APPEAL SUMMARY

Status: Decision Rendered - Reconsideration of ID 16413

Appeal ID: 16560	Project Address: 1314 NW Glisan St
Hearing Date: 2/28/18	Appellant Name: Anne Marie Kuban
Case No.: B-002	Appellant Phone: 5032359400
Appeal Type: Building	Plans Examiner/Inspector: David Bartley
Project Type: commercial	Stories: 2 Occupancy: A-2, B Construction Type: V-B
Building/Business Name: Andina Restaurant	Fire Sprinklers: Yes - Throughout
Appeal Involves: Reconsideration of appeal, occ Change from A2, B, M to A2, B	LUR or Permit Application No.: 17-266543-CO
Plan Submitted Option: pdf [File 1]	Proposed use: Restaurant

ANDINA RESTAURANT
SEISMIC UPGRADE AND CHANGE OF USE
1314 NW GLISAN
PORTLAND, OR 97209

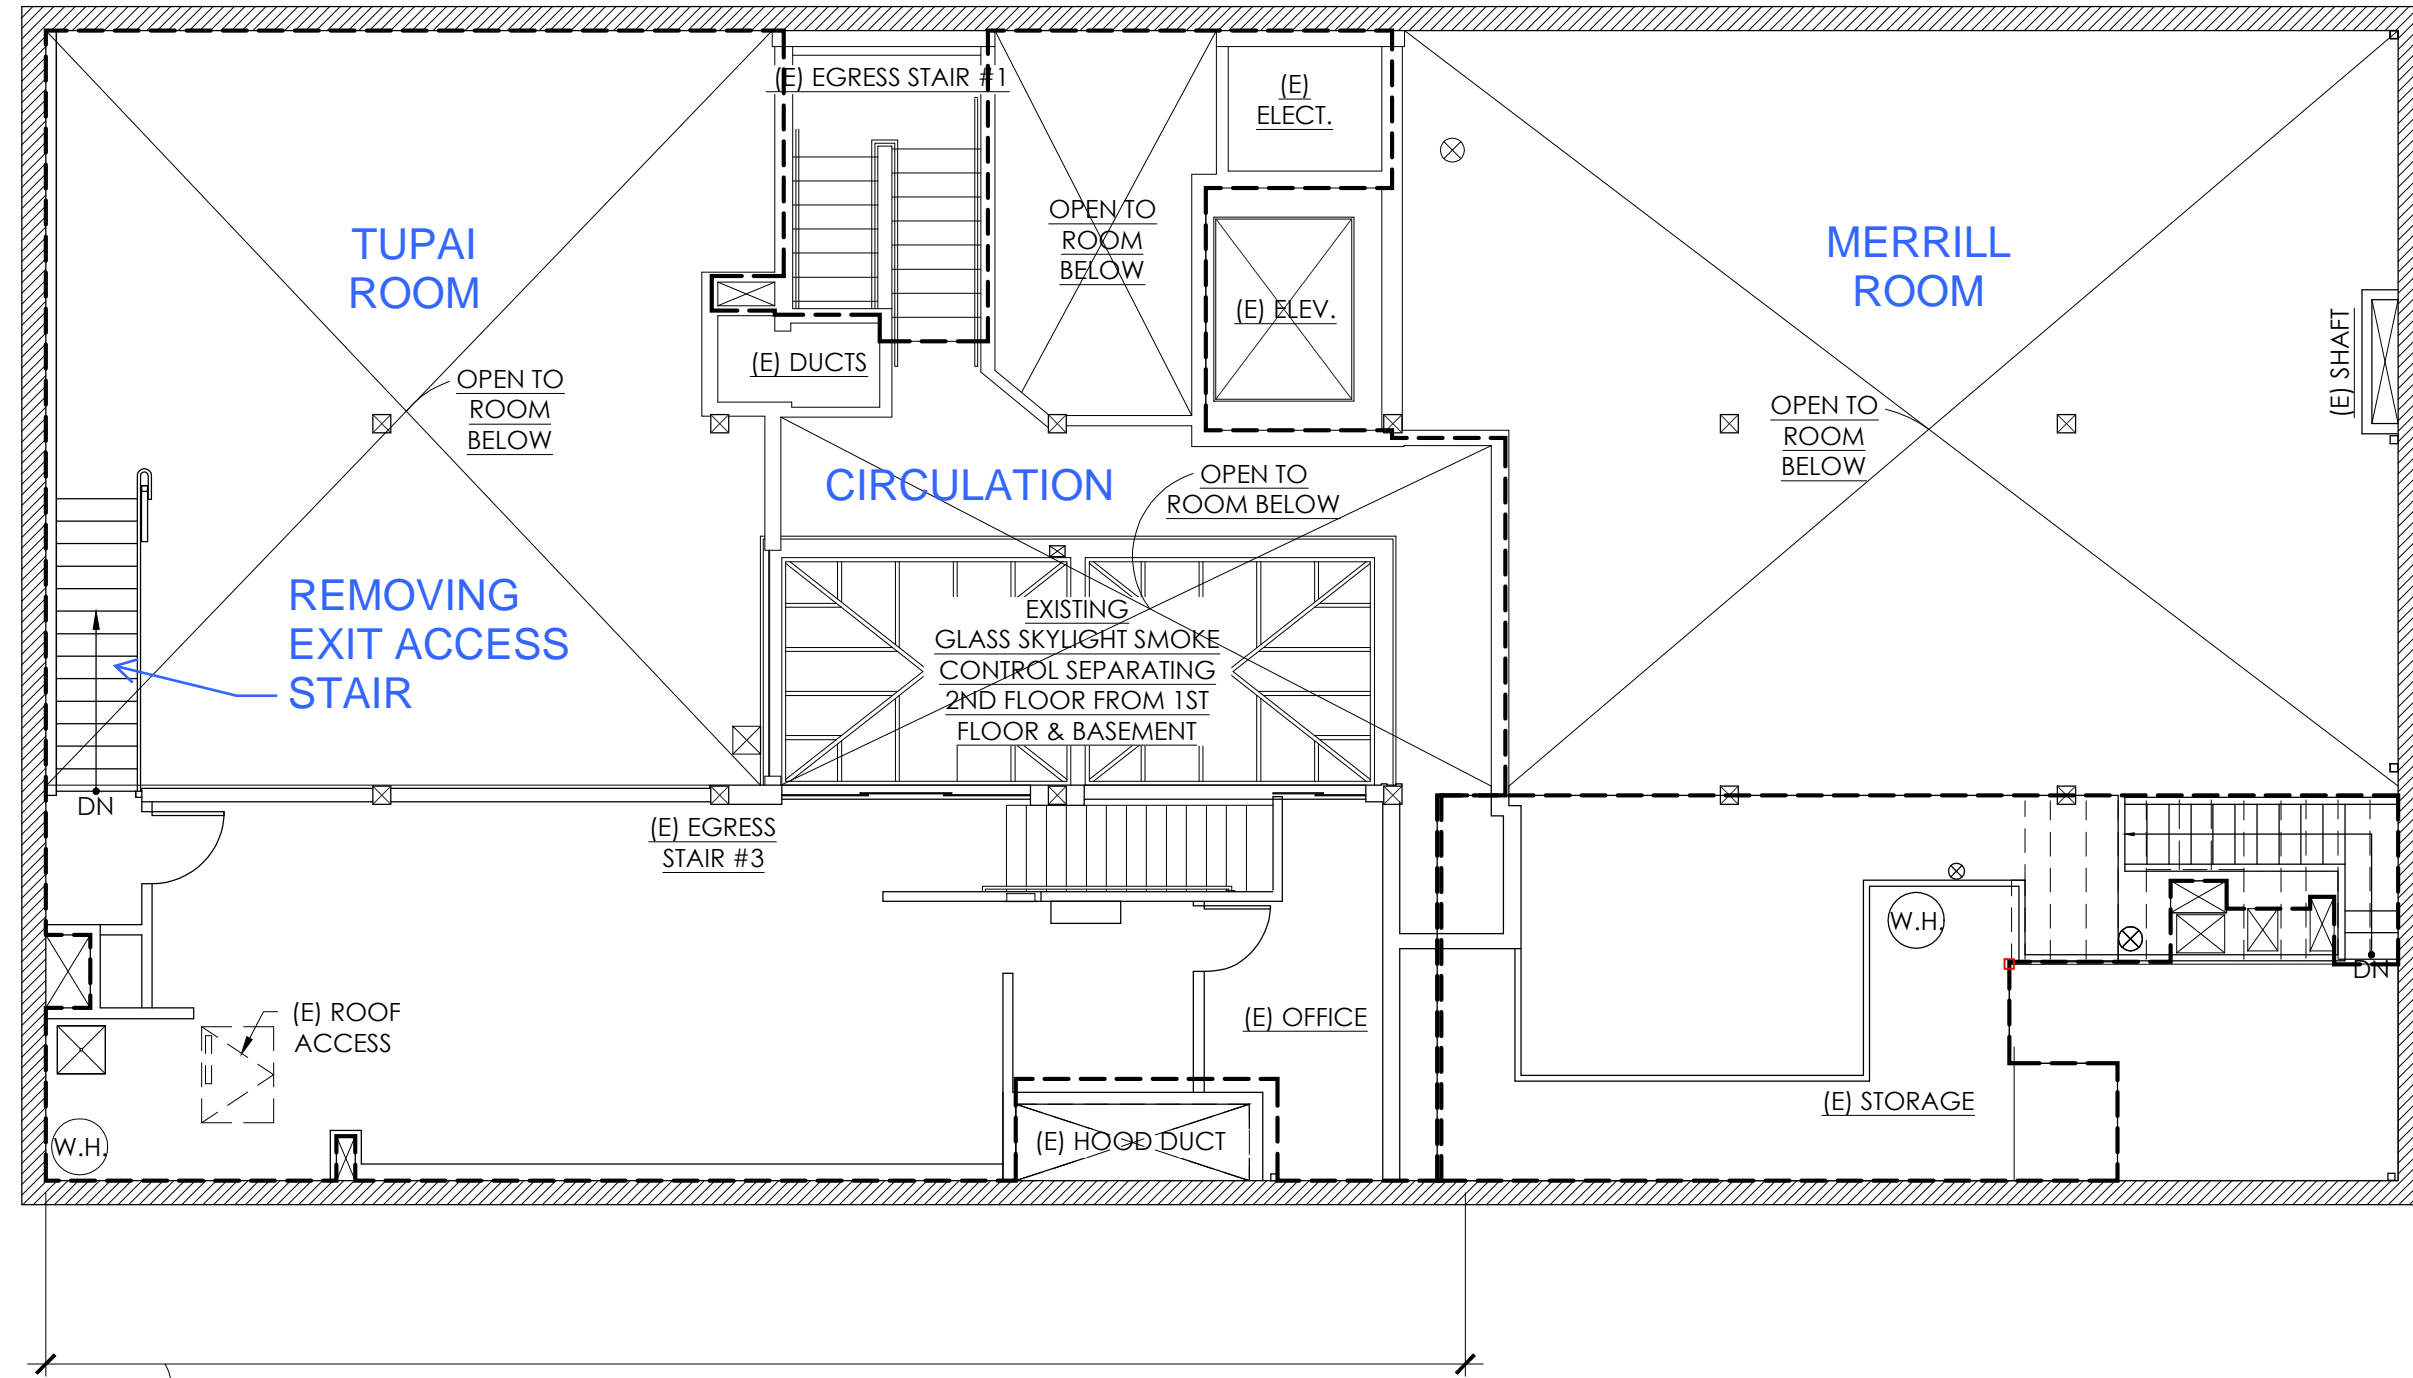
The mezzanine has 2 means of egress:

c. Access exit stair #3 to Stair #1. The travel distance to the exit is approx 194 LF.

d. Interior exit stair #2 (enclosed) that leads directly to the exterior of the building.

The current, revised design meets of the code exception for it to be enclosed. We understand that the scheme was originally denied because that the overall mezzanine size was greater than 1/3 the area of the room(s) below. We respectfully request that this denial be reviewed because the revised mezzanine now complies with 505.2.1.

- 1. Mezzanine area greater than one third of the room it is open to: Denied. Proposal does not provide equivalent Life Safety protection.**
Appellant may contact Jody Orrison (503 823-4539) with questions.
- 2. Mezzanine openness to the room it is within: Denied. Proposal does not provide equivalent Life Safety protection.**
Appellant may contact Jody Orrison (503 823-4539) with questions.
